## RESPONSE TO REQUEST FOR ADDITIONAL INFORMATION

### APR1400 Design Certification

RAI No.: 13-7856

SRP Section: 12.02 – Radiation Sources

Figure 1. Shielding and Layout of Holdup Tank

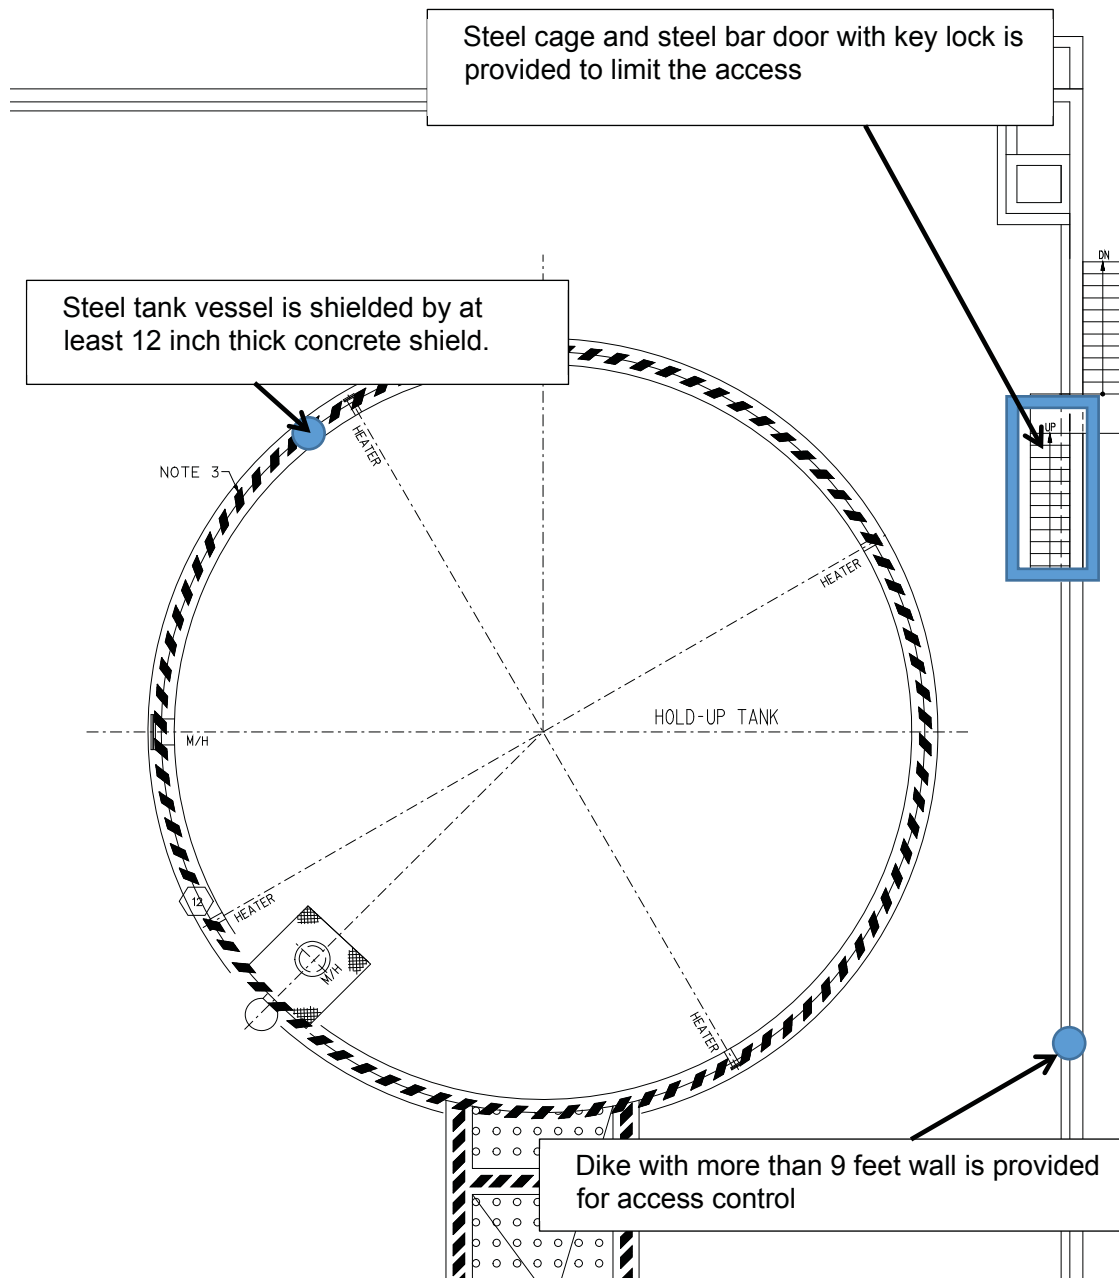
4. FSAR Section 12.2.1.6 indicates that the surface dose rate of these tanks will not exceed 2.5 micro Sieverts per hour. While staff cannot perform dose rate calculations without tank dimensions and parameters (as discussed in Question 2, above), the source terms for the holdup tank and BAST provided in FSAR Table 12.2-13, contain fairly significant quantities of radioactive material. It seems unlikely to staff that the dose on the surface of these tanks would not exceed 2.5 micro Sieverts per hour using the 0.25% failed fuel percentage source term provided in Table 12.2-13. Please provide an analysis that shows the dose rate on the surface of these tanks will not exceed 2.5 micro Sieverts per hour on the surface of these tanks using the 0.25% failed fuel percentage source term provided in FSAR Table 12.2-13. If not, please modify FSAR Section 12.2.1.6 accordingly and provide the radiation zoning for these areas.

5. While the source term for the holdup tank is fairly significant, it appears to be significantly lower than the source term provided for a tank which appears to have a very similar function in another new reactor design. Please discuss all potential input paths of radioactive material to the holdup tank. If potential input paths that would result in a significantly higher source term than what is provided in FSAR Table 12.2-13 exist, please discuss why the current source term is adequate. Please provide the methods, models, and assumptions used in calculating the source term for the holdup tank in FSAR Table 12.2-13 in the response.

- b. As presented in Figure 1, the holdup tank itself is composed of a steel vessel with a minimum 12-inch thick concrete shield wall outside the vessel to ensure that the dose rate outside the tank is less than  $2.5 \mu\text{Sv/hr}$ . This design feature is also applicable to the BAST. The RWMT is not shielded with concrete since the design basis dose rate outside the vessel is low enough to maintain the dose rate below  $2.5 \mu\text{Sv/hr}$  without the concrete shield wall.

4. The Holdup Tank and the BAST are stainless steel tanks with a layer of concrete shield wall surrounding the tank, from bottom to top, with no gap between the tank surface and concrete wall. The thickness of the concrete layer is provided in Table 1 below for convenience. These and other parameters are added to Table 12.2-25 (Please refer to response to Issue #2 above). Please also note that other design features of the tanks are discussed in response to Issue #3 above.
